Amendments to the Drawings:

REMARKS/ARGUMENTS

This is in response to the Office Action mailed July 3, 2006. This response is considered to be timely since it is being filed on August 3, 2006 and the shortened statutory period for reply was set to expire one month from the mailing date of the communication.

FIG. 6

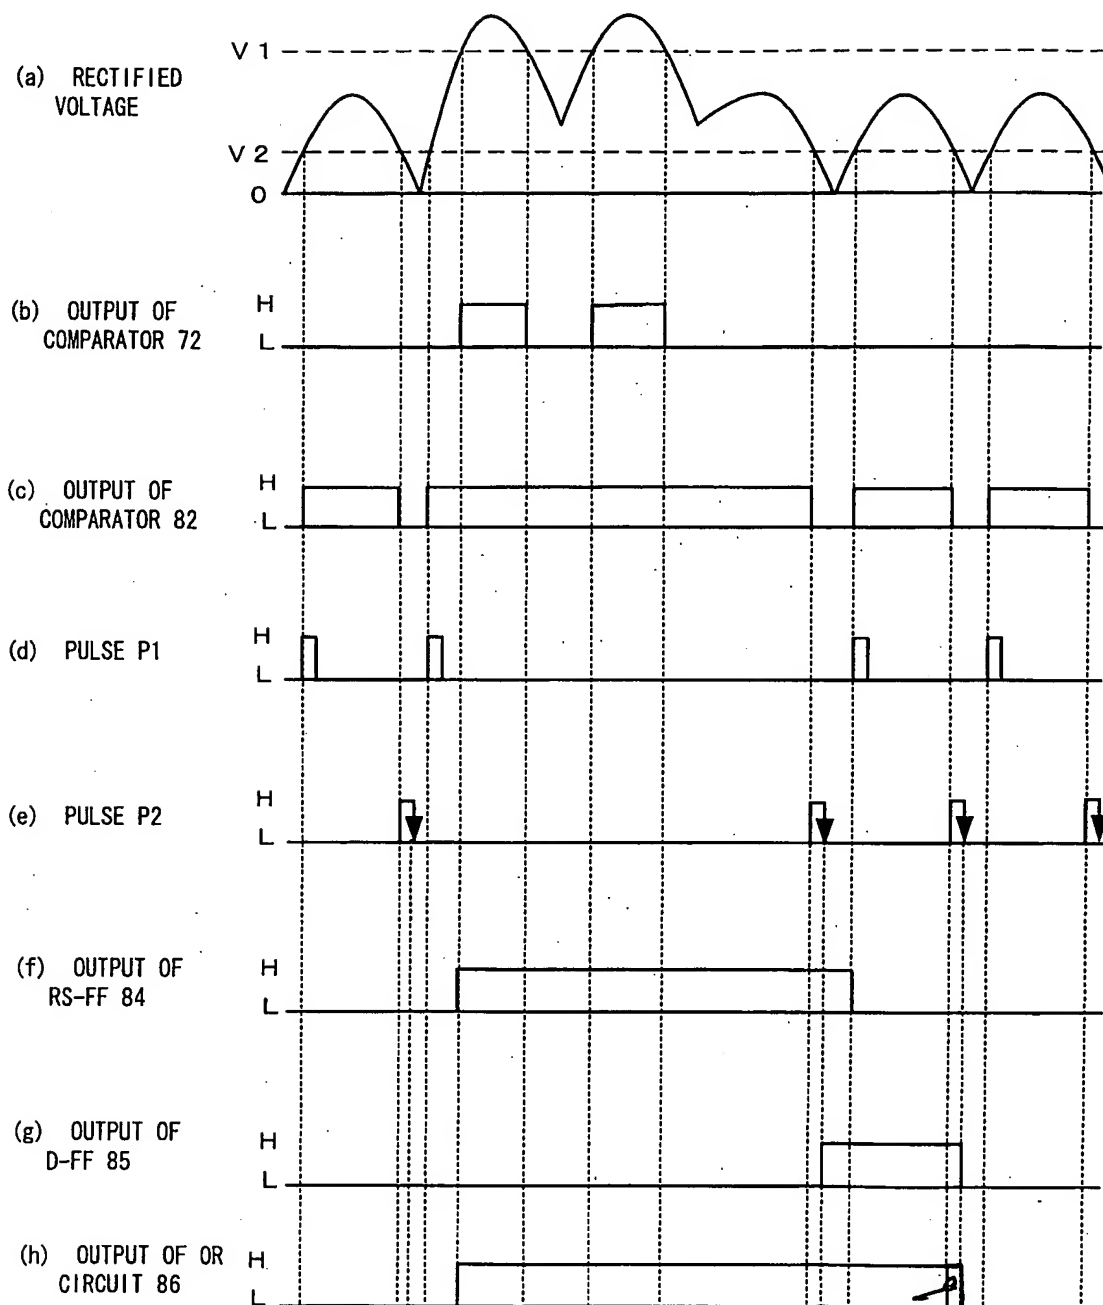
Applicant amends Fig. 6 to correct the illustration of waveform (h) representing the output of OR circuit 86. A redline annotated drawing illustrating the amendment is attached.

Thus, the Specification clearly supports the output of the OR circuit 86 falling to a low level (L) at the fall of pulse P2 and when the output of the D-FF 85 becomes low (L).
